ADDENDUM NO. ONE

JOB NAME: Shoals Library Expansion

PROJECT NUMBER: 23-700-121-1

DATE OF ADDENDUM: 07/30/2024

C100

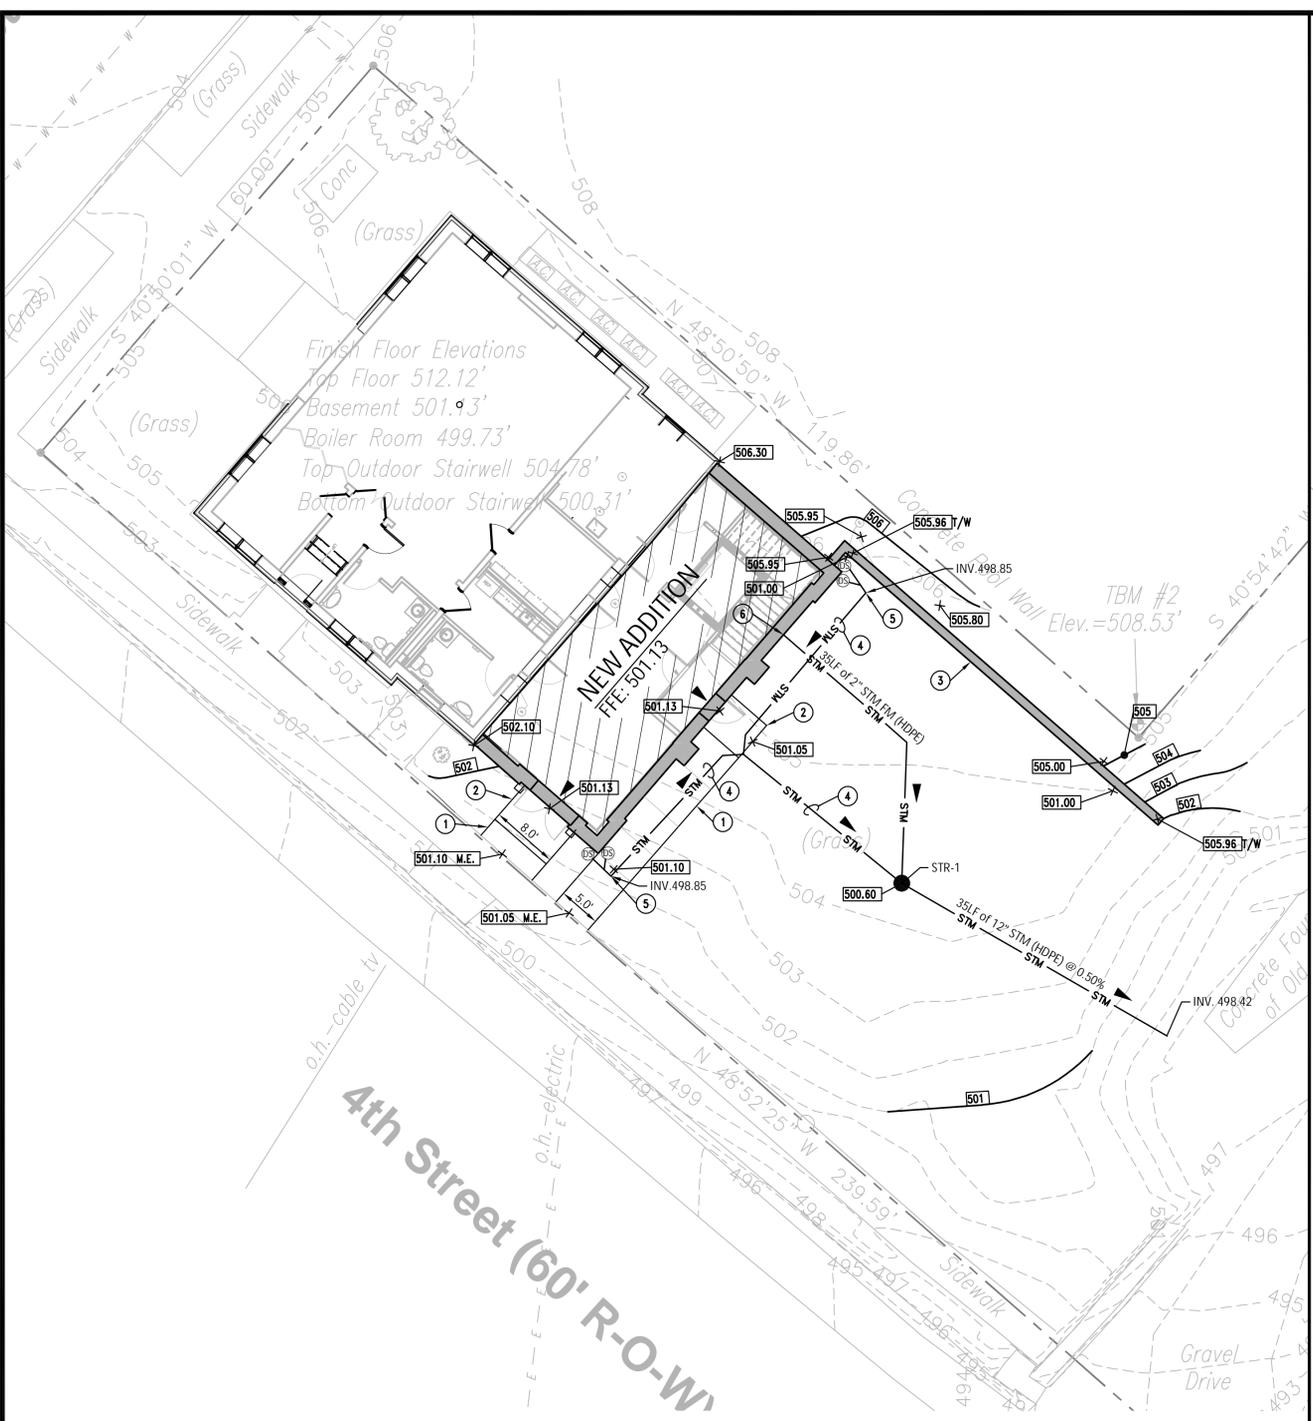
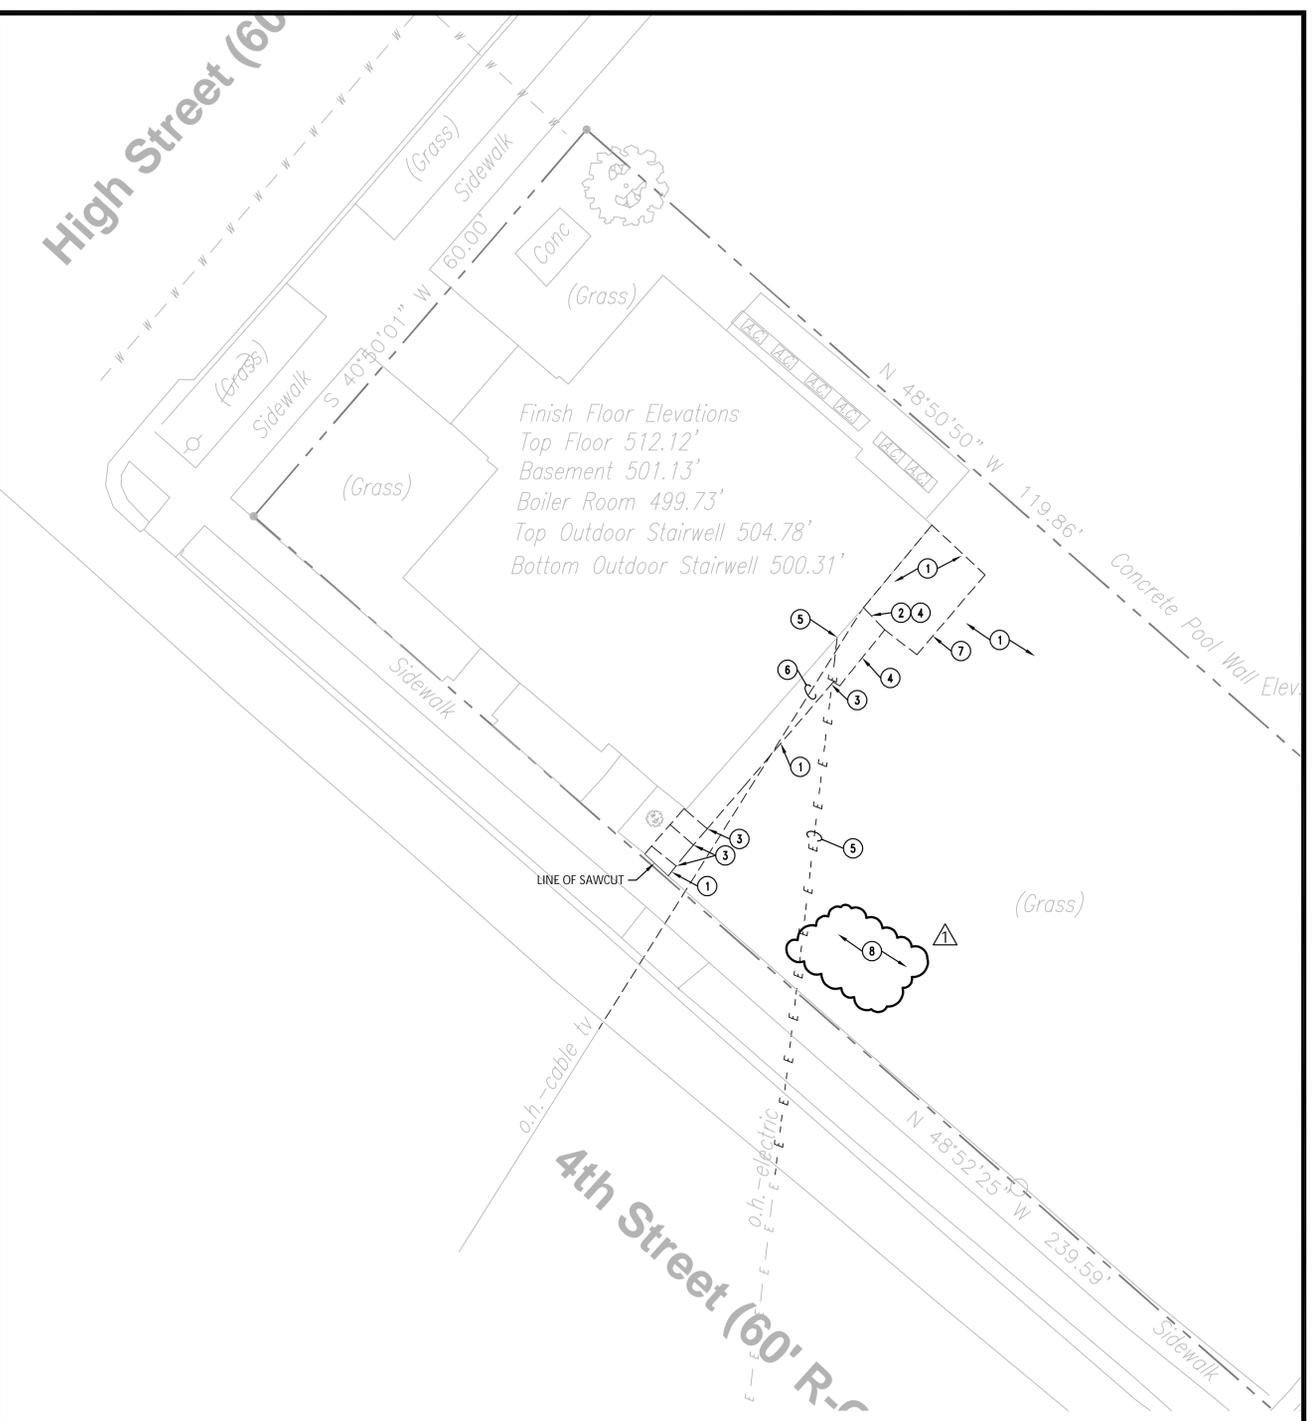
- a. This is clarified in this addendum.
 16. What is to be done with the existing cistern as noted in the Geotech? Infill? Demolish?
 - a. This is addressed in this addendum.

1. G-000 – Cover Sheet:
 - a. Added Sheet AD102.
 - b. Removed Fire Protection Sheets.
2. C100 – Site Development Plan:
 - a. Cistern to be demolished.
3. AD101 – Demo Plans
 - a. Note clarified.
4. AD102 – Demolition Photos and Notes
 - a. Sheet added.
5. AF102 – Second Floor Plan
 - a. Note clarified.
6. AC102 – Second Floor Ceiling Plan
 - a. Note clarified.
7. IN102 – Second Floor Finish Plan
 - a. Note added.
8. E210 – First Floor Lighting Plan
 - a. Note clarified.

- PLAN NOTES**
- REMOVE EXISTING CONCRETE SIDEWALK COMPLETE. MAKE STRAIGHT SAWCUT AT TERMINATION.
 - REMOVE EXISTING CONCRETE WALL COMPLETE.
 - REMOVE EXISTING CONCRETE STAIRS COMPLETE.
 - REMOVE EXISTING RAILINGS COMPLETE.
 - REMOVE EXISTING ELECTRICAL SERVICE AND METER COMPLETE. REFEED TO NEW METER LOCATION. REFER TO ELECTRICAL DRAWINGS FOR MORE INFORMATION.
 - REMOVE EXISTING OVERHEAD CABLE TV COMPLETE. REFEED TO NEW ENTRANCE LOCATION. REFER TO ELECTRICAL DRAWINGS FOR MORE INFORMATION.
 - REMOVE EXISTING COAL CHUTE COMPLETE IN THIS AREA.
 - REMOVE EXISTING ABANDONED BRICK CISTERN IN THIS AREA COMPLETE. EXACT LOCATION AND SIZE OF CISTERN IS UNKNOWN.

3 EXISTING WINDOW DEMOLITION DETAIL
1/2" = 1'-0"

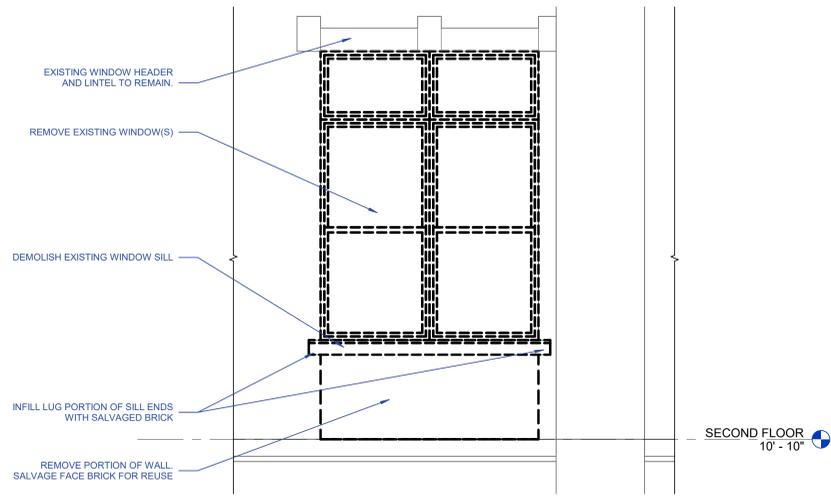
- a. Clarified in this addendum.
4. A-311 indicates use of salvaged brick for the veneer, but the exterior brick walls are not being demolished.
 - a. See detail 3 on AD101. Additionally, there are new doors being created in the existing exterior wall.

DEMO PLANS

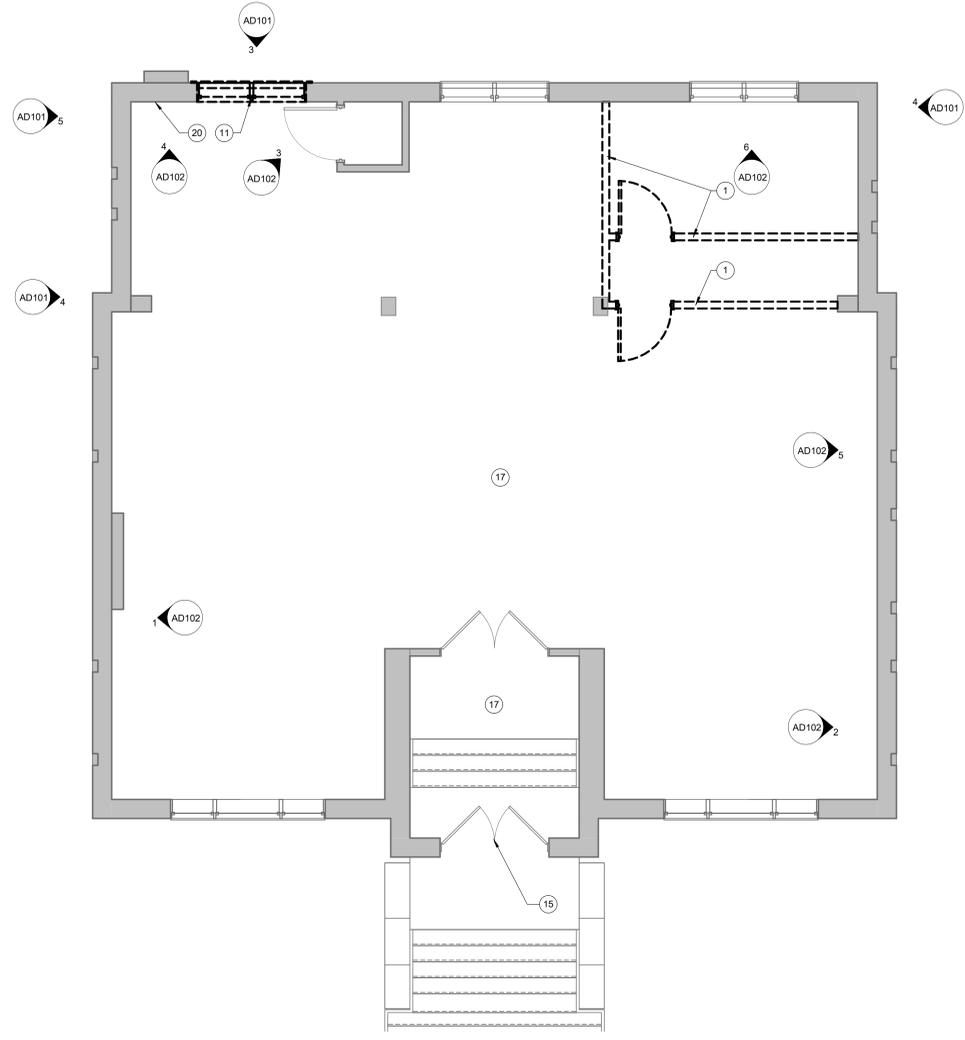
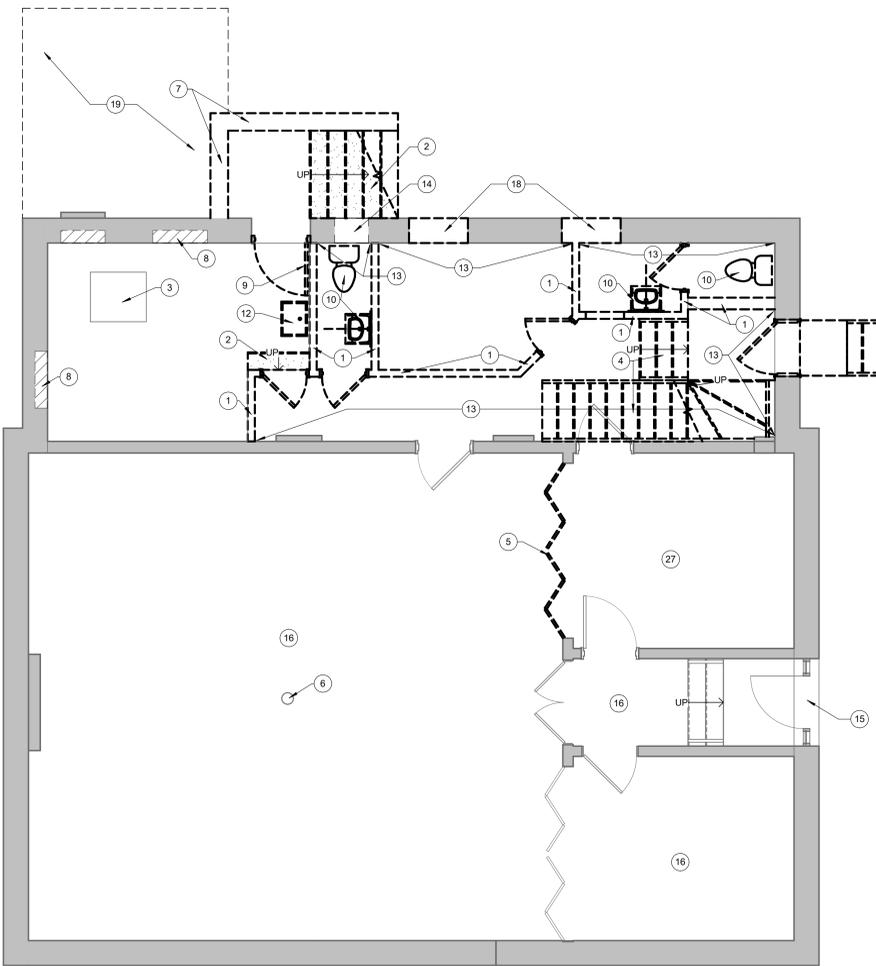
6. Is door security to be included in the bid, or will that be performed by others?
 - a. Access control scope will be by others.
7. Note 17 on AD101 seems to be at odds with Note 5 on IN102.

- a. This has been clarified in this addendum.
8. Note 5 on E210 says "<varies>."
 - a. This has been addressed in this addendum.
9. AD102 is missing. Please confirm if this is supposed to be included.

DEMOLITION PHOTOS AND NOTES

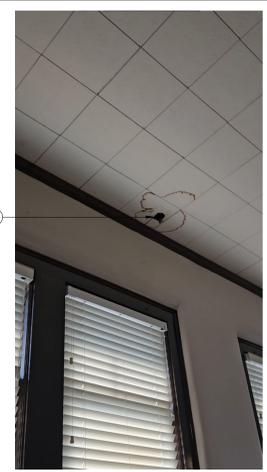
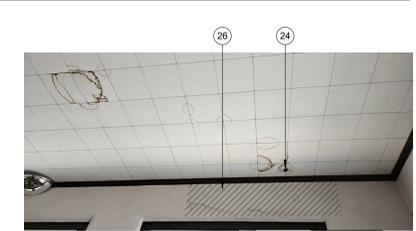
- a. AD102 is included in this addendum.
10. Is Note 5 on AF102 part of the base bid or Alternate #1?
 - a. This is clarified in this addendum.
 11. Is note #5 on AC102 meant to be used?

1 SECOND FLOOR REFLECTED CEILING PLAN
 1/4" = 1'-0"

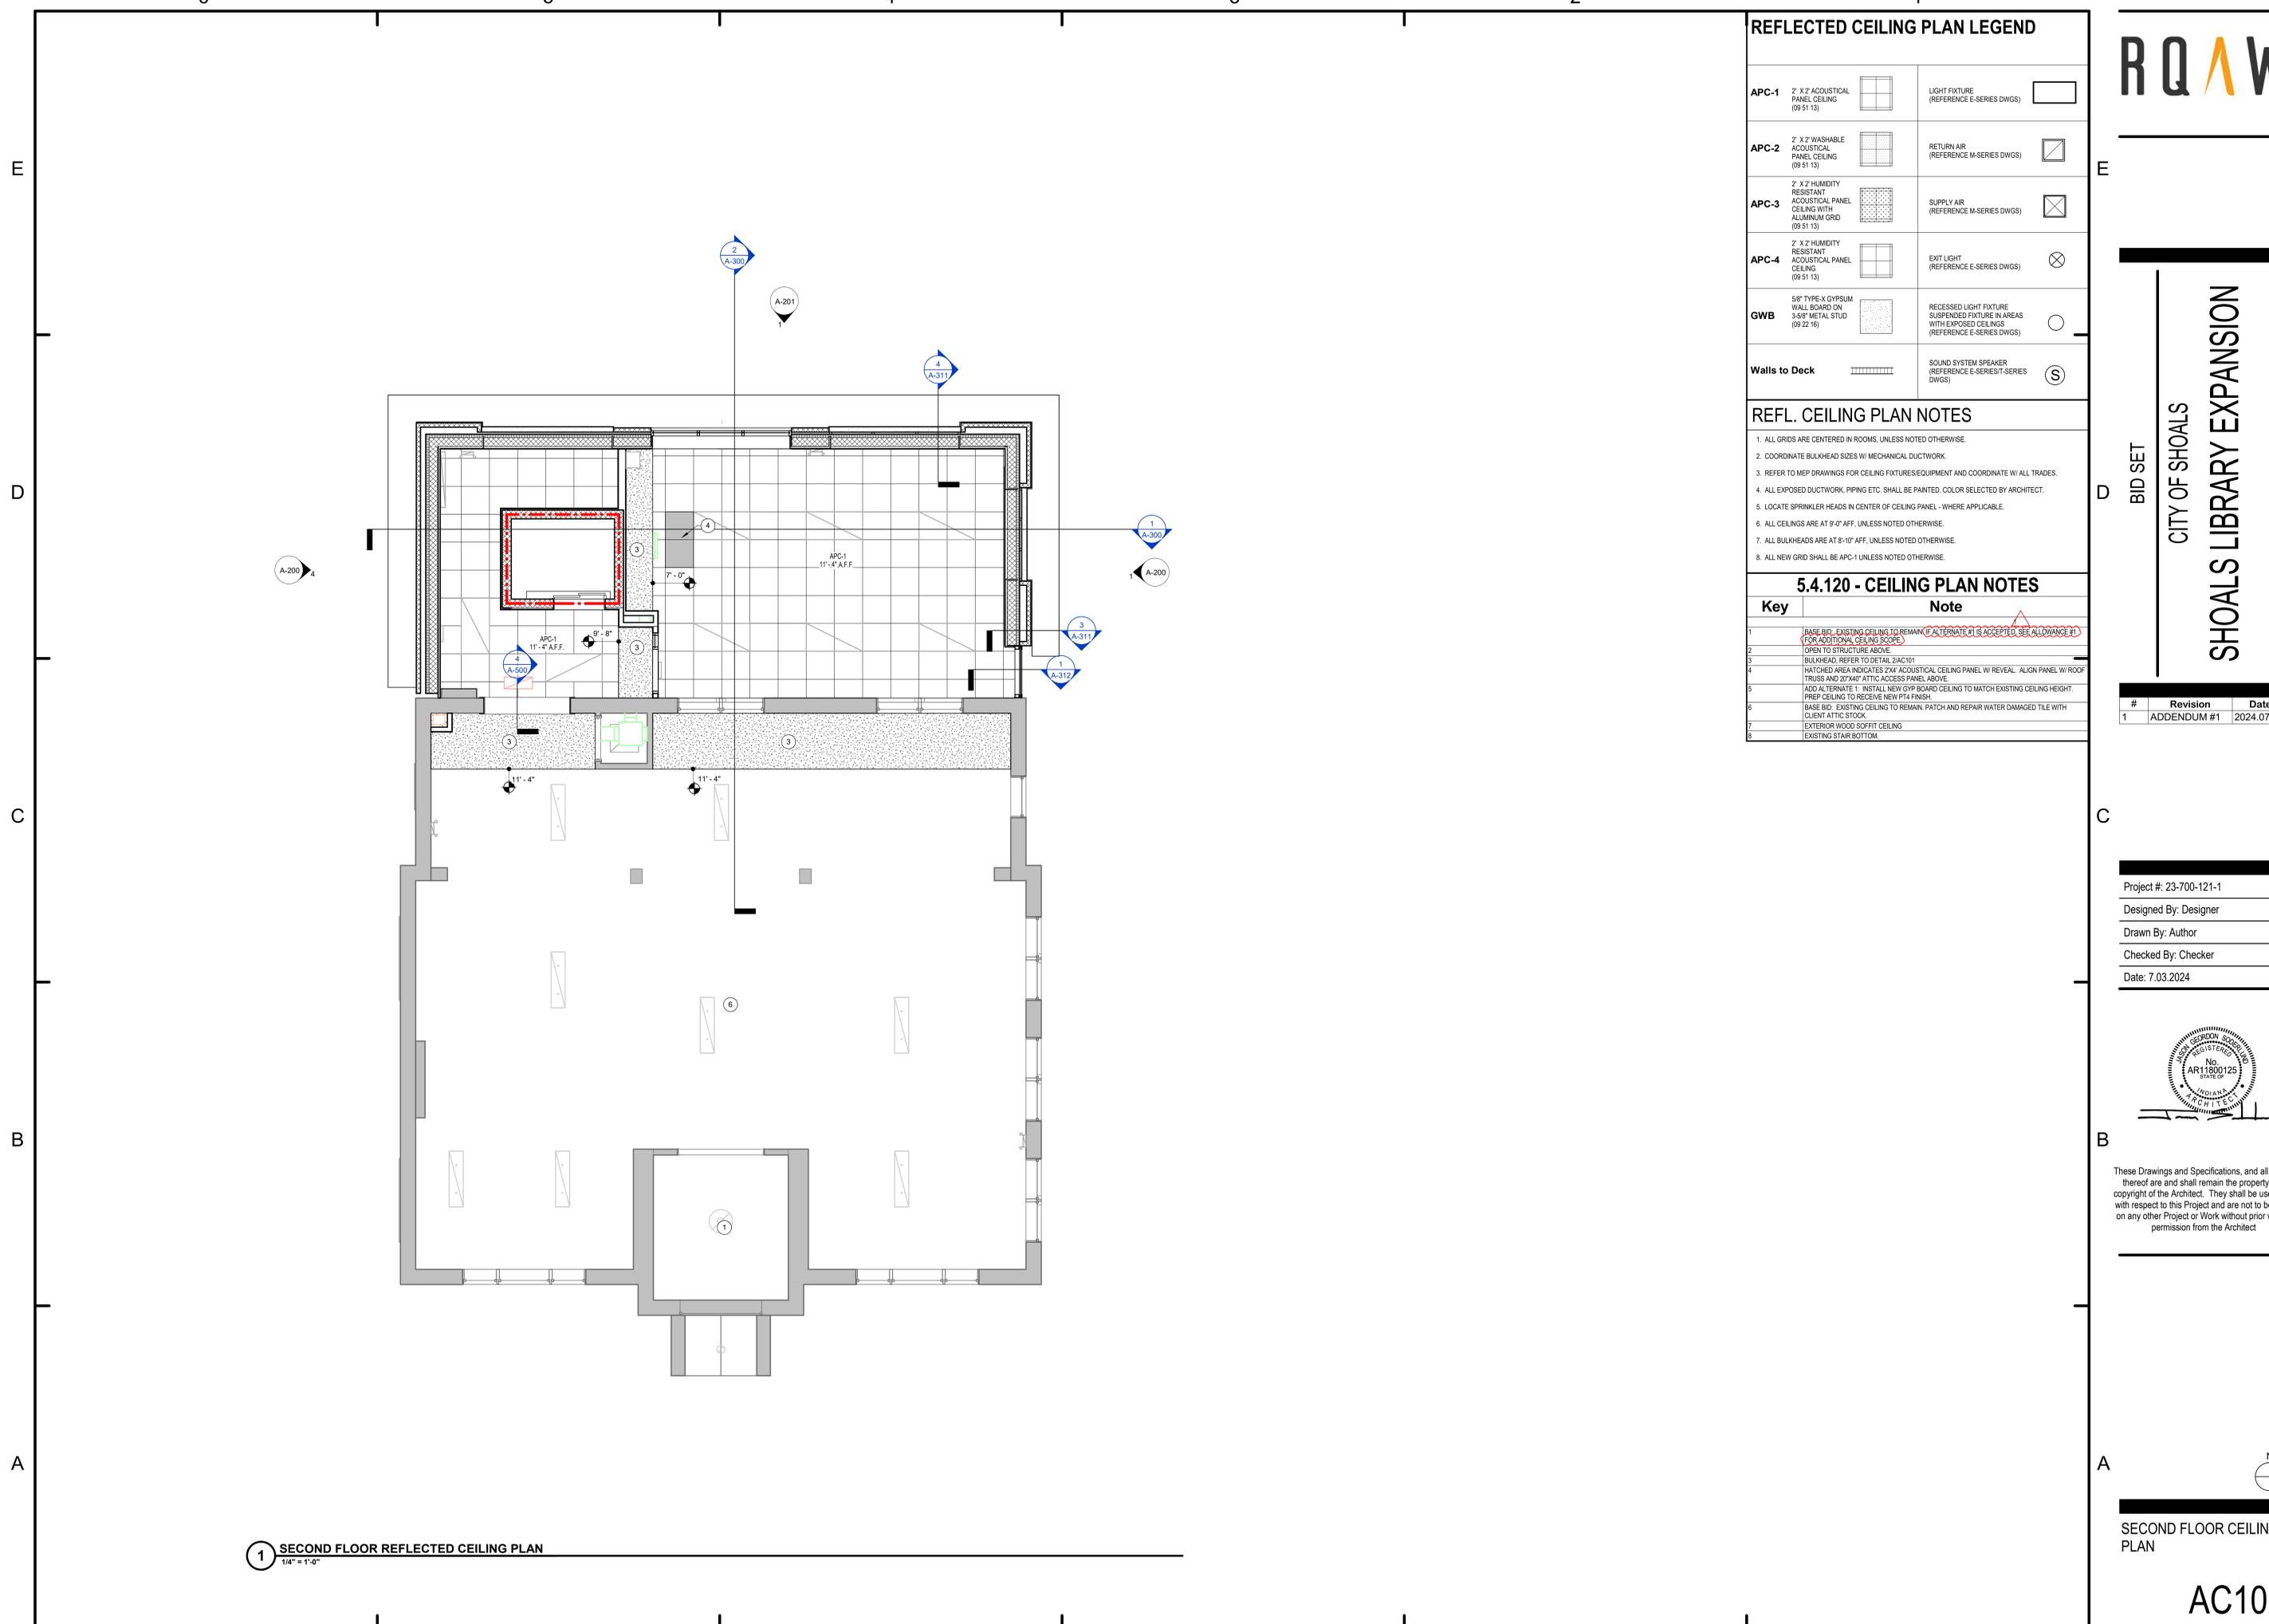
2. Is there a specified elevator company?
 - a. The elevator specification is included in this addendum.
3. AC102 indicates the ceiling is to remain per the base bid, but there is no callout for Alternate 1 to replace it. Is the second floor ceiling not a part of the alternate?

Key	Note
1	BASE BID: EXISTING CEILING TO REMAIN (IF ALTERNATE #1 IS ACCEPTED, SEE ALLOWANCE #1 FOR ADDITIONAL CEILING SCOPE)
2	OPEN TO STRUCTURE ABOVE.
3	BULKHEAD, REFER TO DETAIL 2/AC101
4	HATCHED AREA INDICATES 2X4 ACOUSTICAL CEILING PANEL W/ REVEAL. ALIGN PANEL W/ ROOF TRUSS AND 20" MAX ATTIC ACCESS PANEL ABOVE.
5	ADD ALTERNATE 1: INSTALL NEW GYP BOARD CEILING TO MATCH EXISTING CEILING HEIGHT. PREP CEILING TO RECEIVE NEW PT4 FINISH.
6	BASE BID: EXISTING CEILING TO REMAIN. PATCH AND REPAIR WATER DAMAGED TILE WITH CLIENT ATTIC STOCK.
7	EXTERIOR WOOD SOFFIT CEILING
8	EXISTING STAIR BOTTOM
